To: Kristopher Byrd, Well Construction and Compliance Section Manager
From: Travis Kelly, Well Construction Program Coordinator
Subject: Review of Water Right Application G-19139
Date: August 24, 2021

Application # G 19139

WATER RESOURCES DEPARTMENT**MEMO****08/12/2021****TO: Application G- 19139****FROM: GW: Mike Thoma**
(Reviewer's Name)**SUBJECT: Scenic Waterway Interference & General/Local Surface Water Evaluation for Deschutes Ground Water Study Area**

TO: Water Rights Section Date 08/12/2021
 FROM: Groundwater Section Mike Thoma
 Reviewer's Name
 SUBJECT: Application G- 19139 Supersedes review of _____
 Date of Review(s) _____

Application Review Map showing water-level wells and geology (from Sherrod et al., 2004)

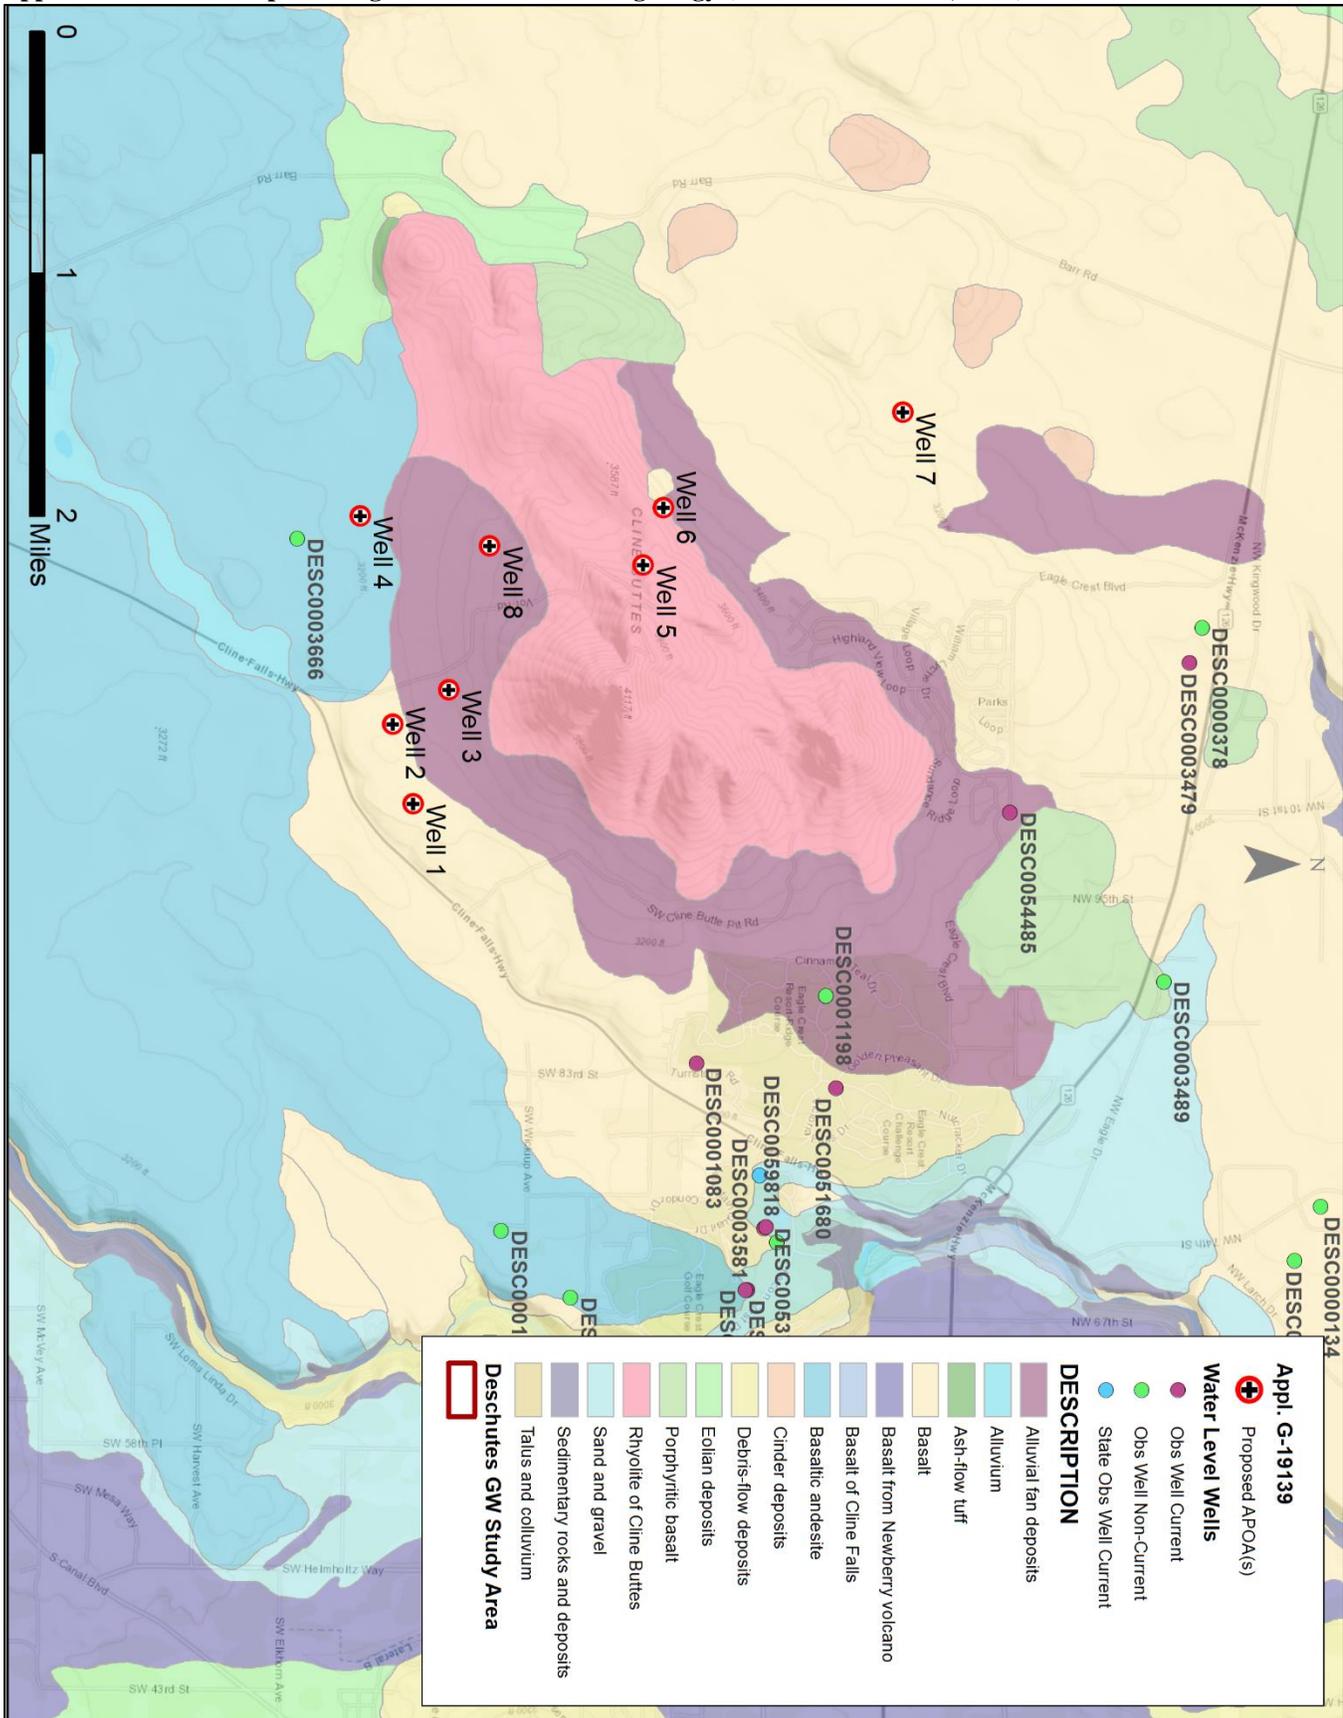
There are several wells in the area producing from the same groundwater source as the proposed POAs that have water level records that show a long-term declining trend. There are a few wells in the immediate vicinity of Cline Buttes that do not show the same long-term declines, but the majority of wells in the broader area show significant, monotonic declines (see hydrograph below). A joint study by the USGS and OWRD concluded that this widespread decline, which extends toward Powell Buttes to the east, is due to climate changes and canal lining (which have reduced recharge to the aquifer locally) as well as groundwater pumping (Gannett, et. al., 2013). The specific reason why wells closer to Cline Butte are not showing the same declines may be due to local heterogeneity (lateral and vertical) within the aquifer system, less groundwater pumping in the immediate area, or other factors, but those wells and trends do not represent the regional aquifer-system trend. Since existing groundwater appropriation has been found to be contributing to water level declines in the area, any new appropriation will continue or increase those declines and so the proposed new use is not within the Capacity of the Resource.
